March 26, 2015

Mr. Thomas Herrera  
United States Nuclear Regulatory System  
Materials Safety & Inspection Branch  
Division of Industrial and Medical Nuclear Safety  
Two White Flint North  
11545 Rockville Pike  
North Bethesda, MD 20852-2738

RE: REQUEST FOR ADDITIONAL INFORMATION, METSO AUTOMATION USA, INC., AMENDMENT  
REQUEST DATED JANUARY 15, 2015

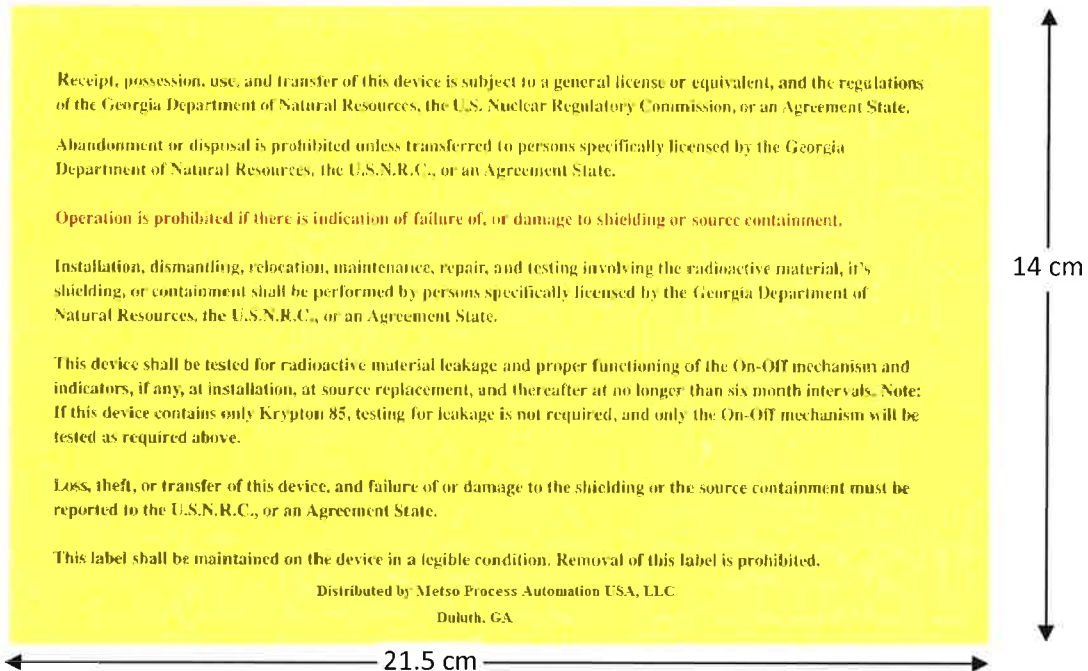
4. The GL Rules and Regulations Label will identify the distributor and location as follows:

5. The Label will be of a tough, industrial vinyl glued to the outside of the sensor as shown in the schematic below. The label is approximately 14 cm x 21.5 cm.

a. NR-0596-D-110-G: BG-V or BG-V with Air

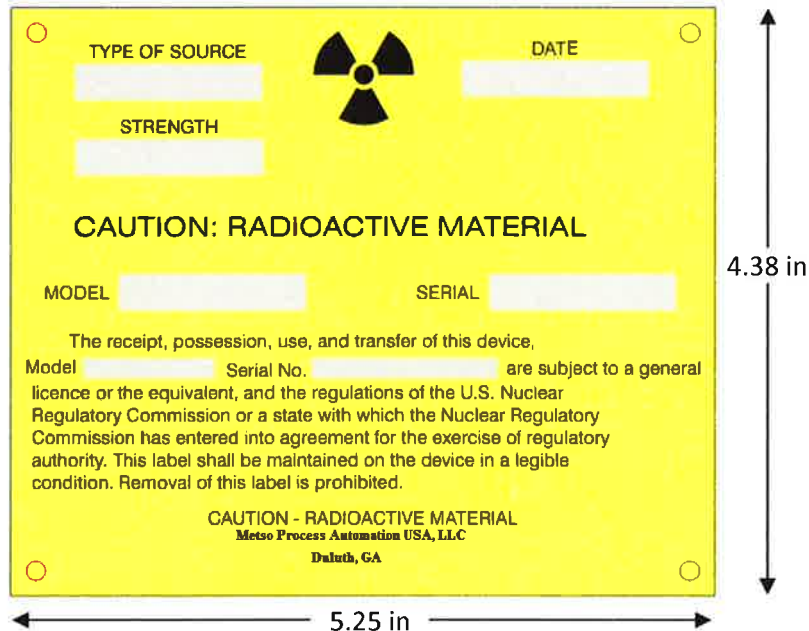
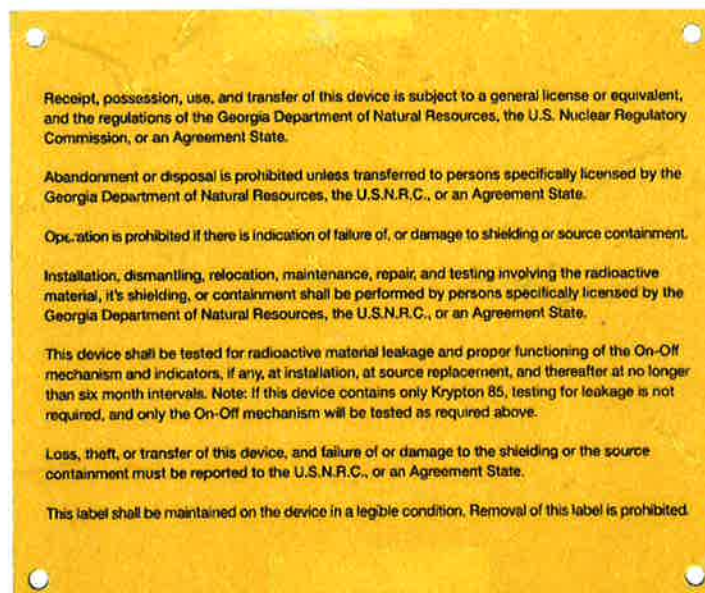
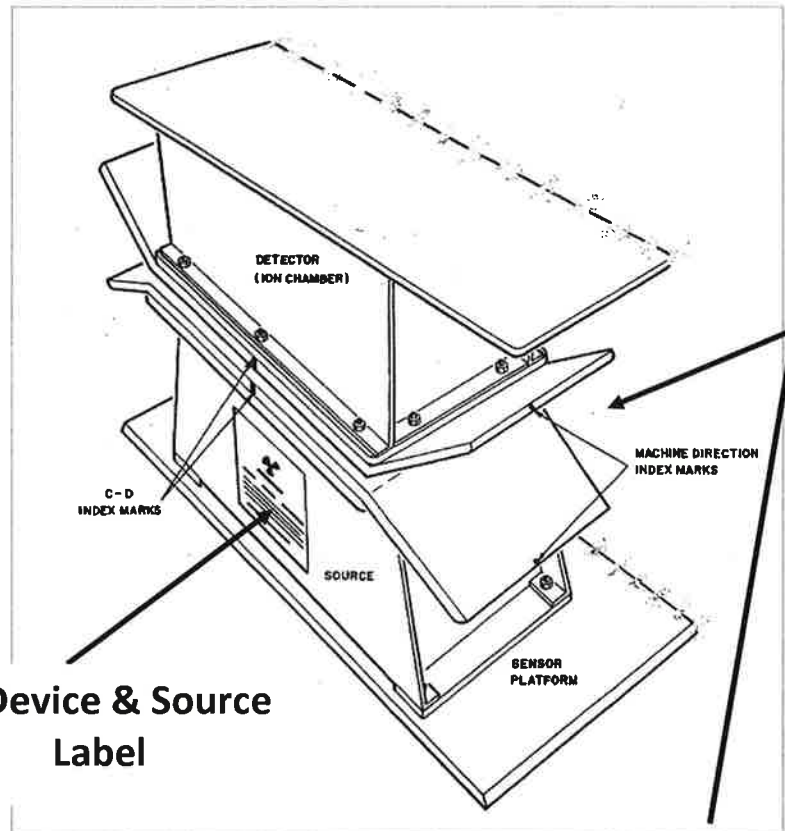
6. Example of labels for NR-0596-D-110-G and NR-0596-D-114-G

Both labels are made of aluminum or steel, and are attached using rivets, epoxy, or other long lasting, durable adhesive. Dimensions of both labels are the same.

The labels will be attached on each side of the sensor as shown below.

GL Rules & Regs Label

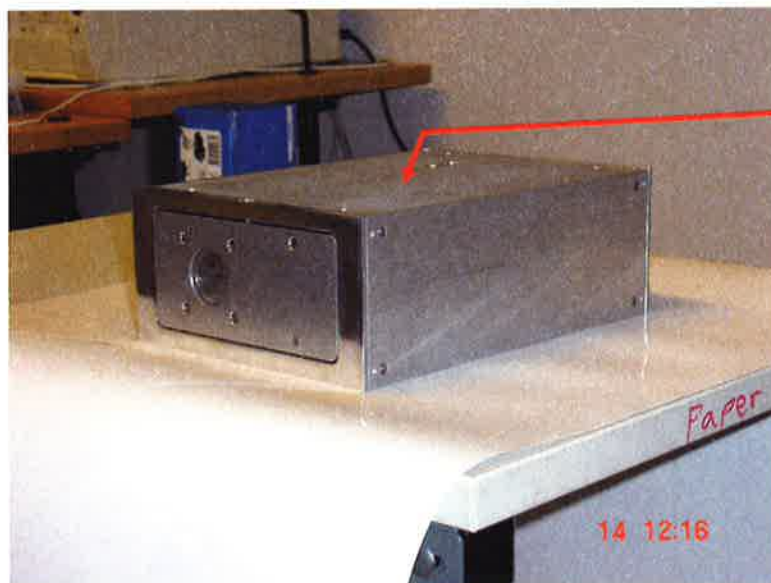
The GL Rules and Regulations Label is attached to the device on the opposite side of the device from the Source and Device ID Labels. The following is an example of the label with the name and location of the distributor identified.

The Label will be located on the sensor as shown, opposite the Source and Device ID Labels.
